FIRE SAFETY INSPECTION REPORT

FAKIR APPARELS LTD.

ACCORD
on Fire and Building Safety in Bangladesh

September 1, 2014

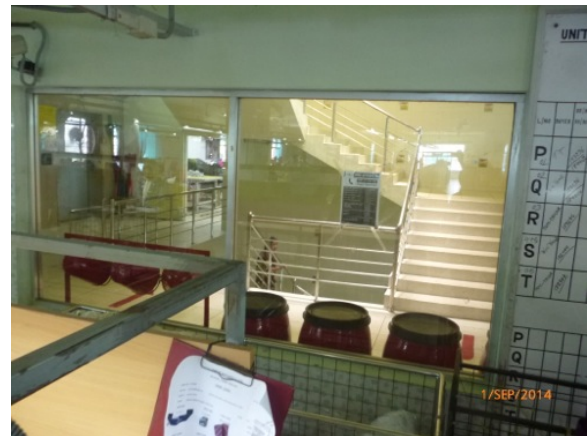
No.	Category	Finding	Recommendation	Remediation Timeframe
F-1	Fire Rated Construction	Rooms used for combustible storage in ground floor are not separated by fire-rated construction. (Ground floor).	Provide dedicated storage rooms separated by minimum 1-hr fire-rated construction.	Within 3 months
F-2	Fire Rated Construction	The exit stairs are not separated from work areas, other spaces on each floor by fire-rated construction.	Provide minimum 1.5-hr fire rated doors and seal all unprotected openings to separate the exit stairs from work areas and other building spaces on all floor levels. Ensure that the fire doors are self-closing and positive latching and that they are provided with fire exit (panic) hardware where serving production floors. If fire doors are required to be held open for functional reasons, provide automatic-closing devices tied to the fire alarm system.	Within 3 months

F-4 Egress

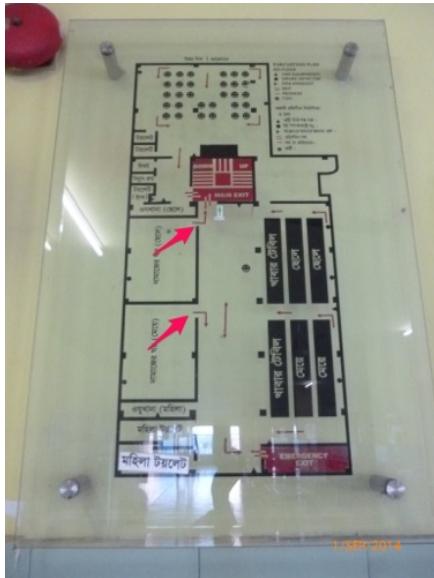
Both exit stairs discharge inside the building and has opening door going to storage room.

Provide 2-hr fire-rated exit passageway leading directly outside (vestibules to separate any storage areas).

Or

Provide sprinkler protection for discharge floor in accordance with NFPA 13.

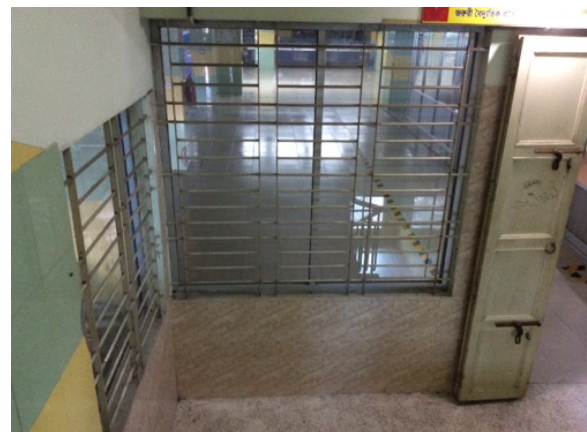
F-5	Fire Rated Construction	All exit stairs were not separated from work areas and other spaces on each floor by fire-rated construction. The Building 2/3 exit stairs had unprotected openings to the factory floor on all floors. The Building 3 northwest exit stair had a raised walkway to Building 1 and washroom and office areas that discharged to the exit enclosure on the first floor, a store room was also present within the exit enclosure on the sixth floor.	Provide minimum 1.5-hr fire rated doors and seal all unprotected openings to separate the exit stairs from work areas and other building spaces on all floor levels. Ensure that the fire doors are self-closing and positive latching and that they are provided with fire exit (panic) hardware where serving production floors. If fire doors are required to be held open for functional reasons, provide automatic-closing devices tied to the fire alarm system.	Within 3 months

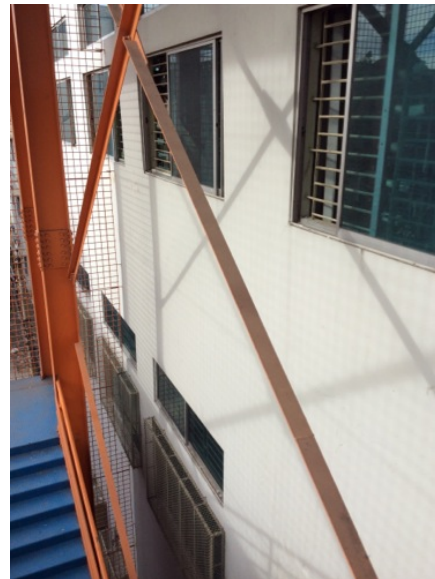
F-6	Fire Rated Construction	The Building 16 exterior exit stair had unprotected openings to the building interior.	Seal all unprotected openings to the building interior, adjacent to and extending at a distance of up to 10 ft. from the end of the exit stair.	Within 3 months
-----	-------------------------	--	---	-----------------

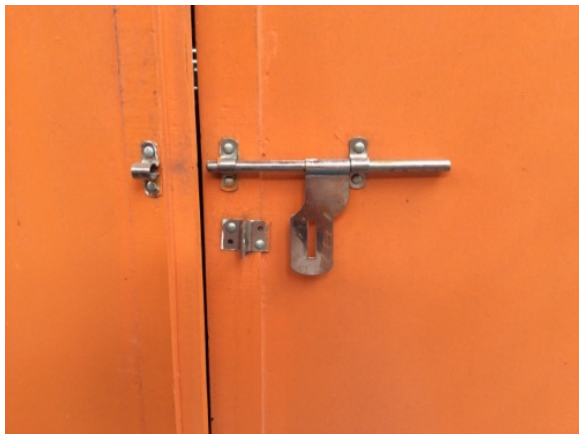
F-12	Egress	Egress doors with locking features are provided at building exits, exit stairs, along egress routes and at exit discharge in Building 2/3 and at building exits, exit stairs and exit discharge in Building 2/3. All doors were not open and unlocked during the inspection, specifically access to the Building 2 northwest rooftop exit stair.	Remove locking features from all egress doors. If locks are required for security reasons, utilize special door locking features complying with NFPA 101.	Immediate
------	--------	--	---	-----------

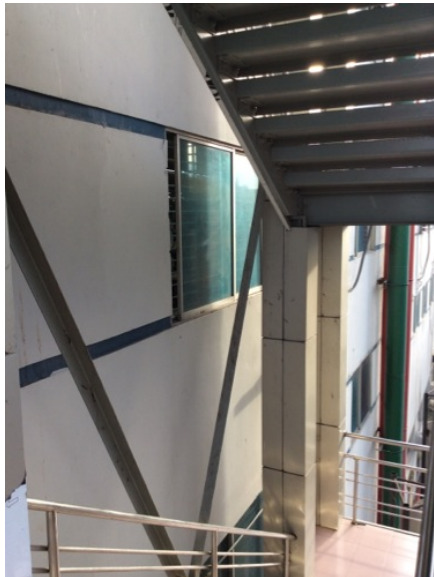
F-2	Fire Rated Construction	The exterior exit stair had unprotected openings to the building interior.	Seal all unprotected openings to the building interior, adjacent to and extending at a distance of up to 10 ft. from the end of the exit stair.	Within 3 months

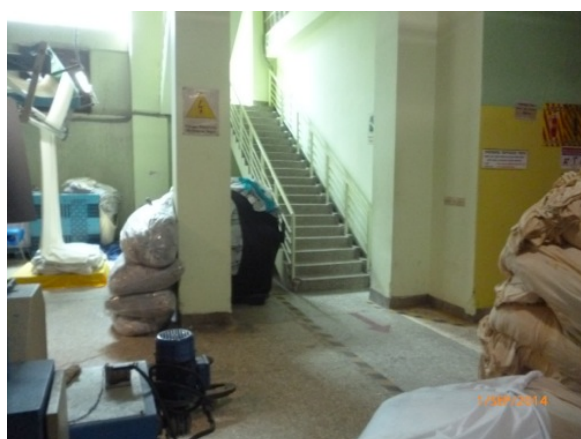
F-4	Egress	Both exit stairs discharge inside the building and has opening door going to storage room.	Provide 2-hr fire-rated exit passageway leading directly outside (vestibules to separate any storage areas). Or Provide sprinkler protection for discharge floor in accordance with NFPA 13.	Within 6 months
-----	--------	--	--	-----------------
